ADDENDUM
to
Final Environmental Impact Report

**Southern California Edison's
West of Devers Upgrade Project**

SCH #2014051041

April 2016

Figure Ap.5-5b
Updated Description of Phased Build
Alternative (February 2016) on Segment 5

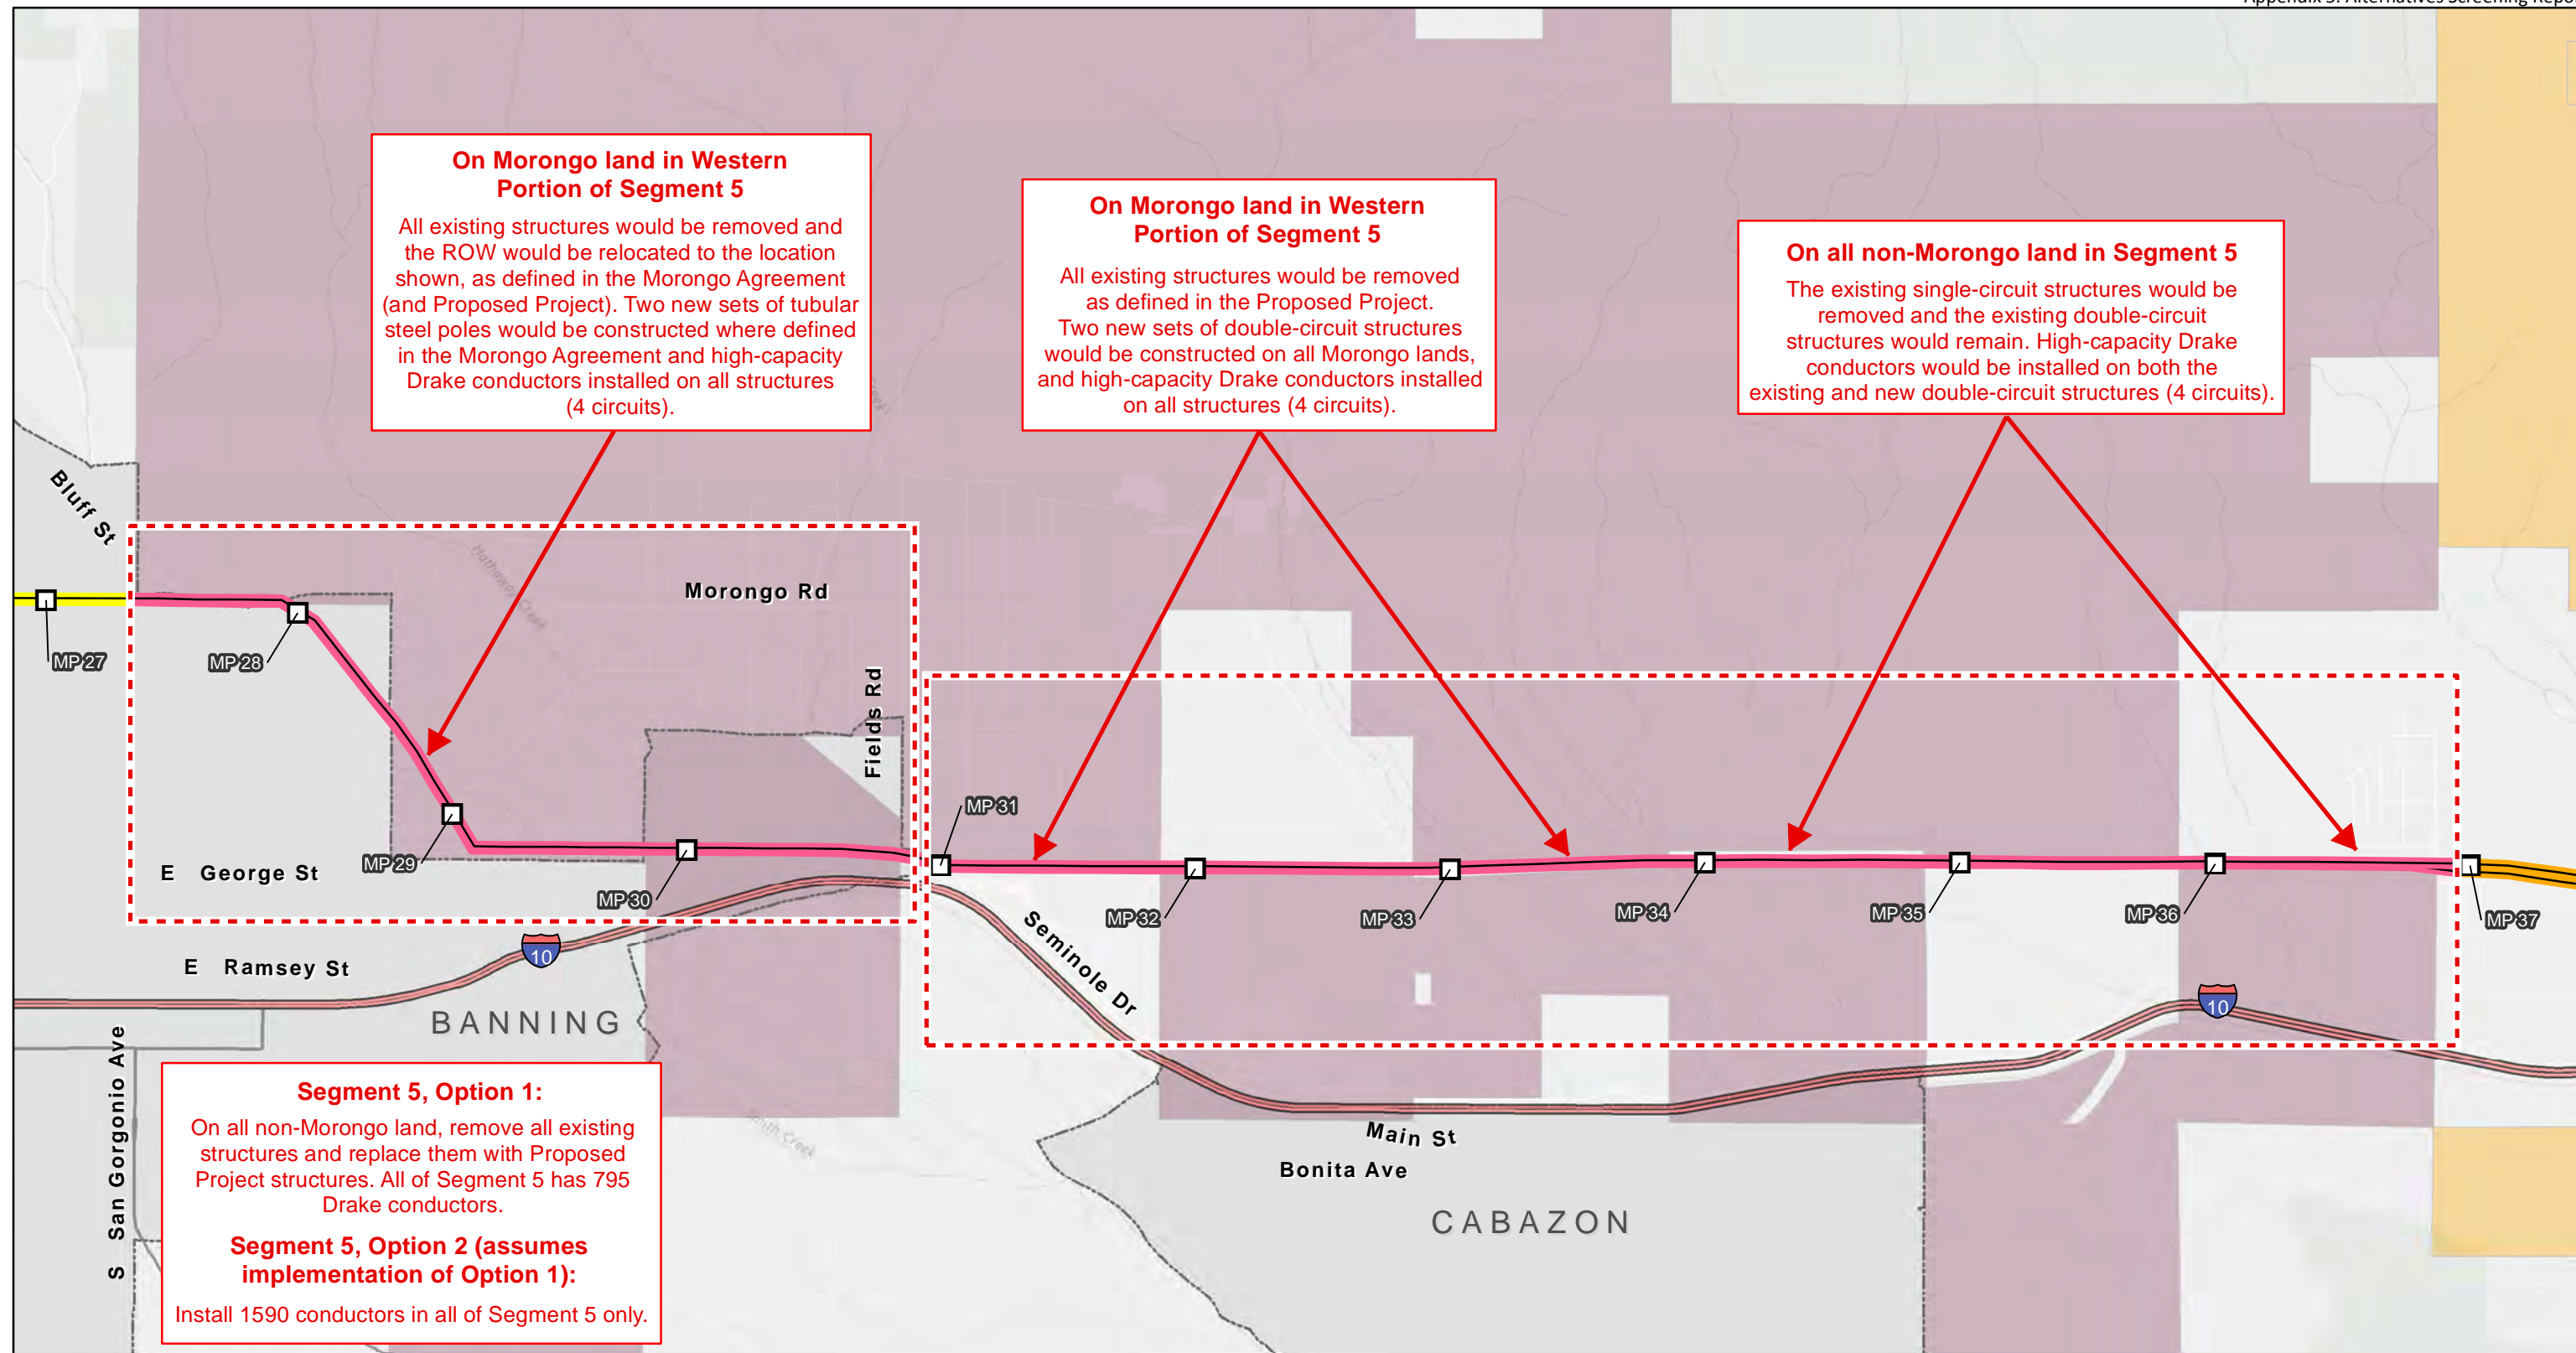
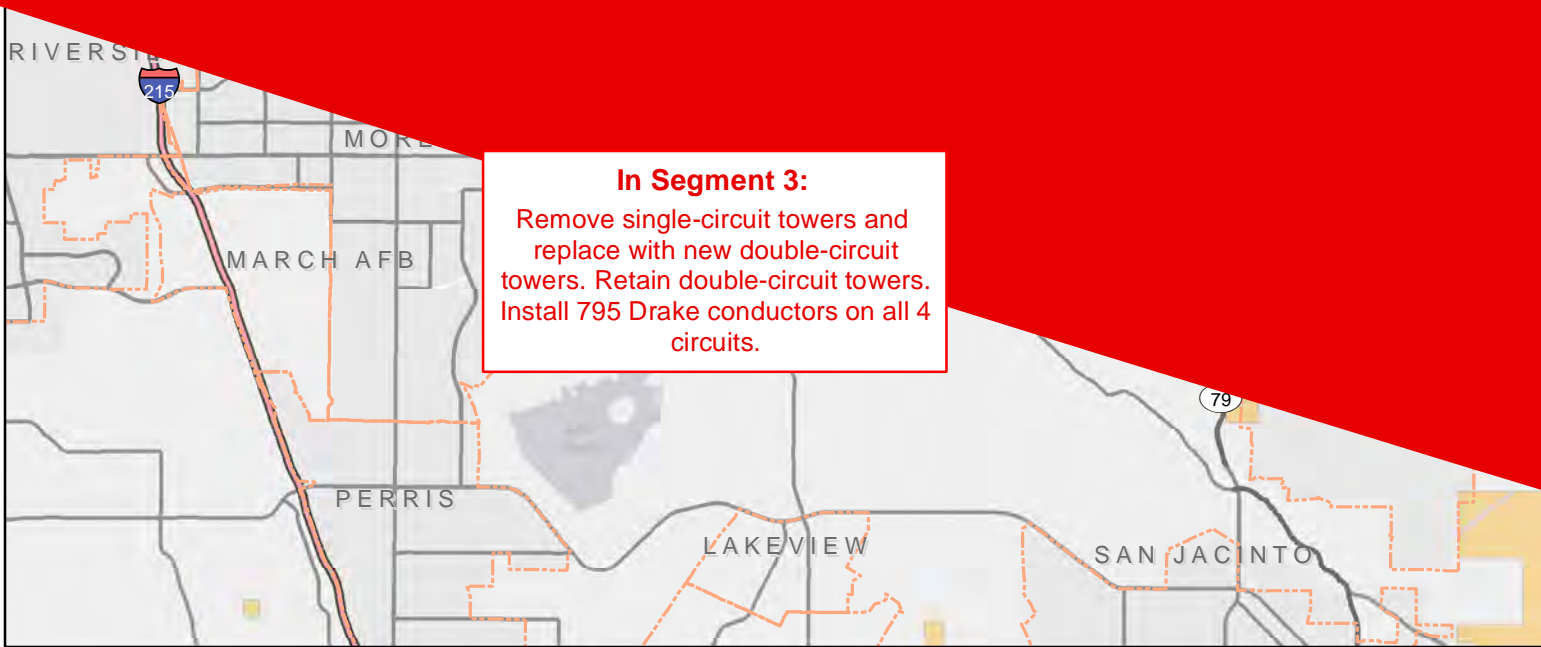
In Segment 5 on Morongo land, the Phased Build Alternative ~~structures would look be exactly the same as those of very much like~~ the Proposed Project, as illustrated in Figure Ap.5-5b, and would incorporate the Morongo relocation of a part of the ROW and use of tubular steel poles. Under the SCE-Morongo ROW agreement, the Morongo Band may conclude that the Phased Build Alternative does not satisfy SCE’s obligation to timely obtain all required regulatory approvals of the Proposed Project. If the Morongo Band concludes that this alternative does not satisfy SCE’s obligations, the Morongo Band could direct the Department of Interior to cancel the ROW, which would create a legal impediment to this project alternative.

In Segment 1:
Re-use existing double-circuit towers and install new 795 Drake conductors.

In Segment 4:
Remove single-circuit towers and replace with new double-circuit towers. Retain double-circuit towers. Install 795 Drake conductors on all

On all Morongo land in Segment 5:
All existing structures would be removed and the structures in the Proposed Project would be installed. Tubular steel poles (at western end) and lattice steel towers (remainder of Morongo lands) would be constructed, as defined in the Morongo-SCE Agreement.

In Segment 2:
Re-use 4 circuits existing double-circuit towers and install new 795 Drake conductors.
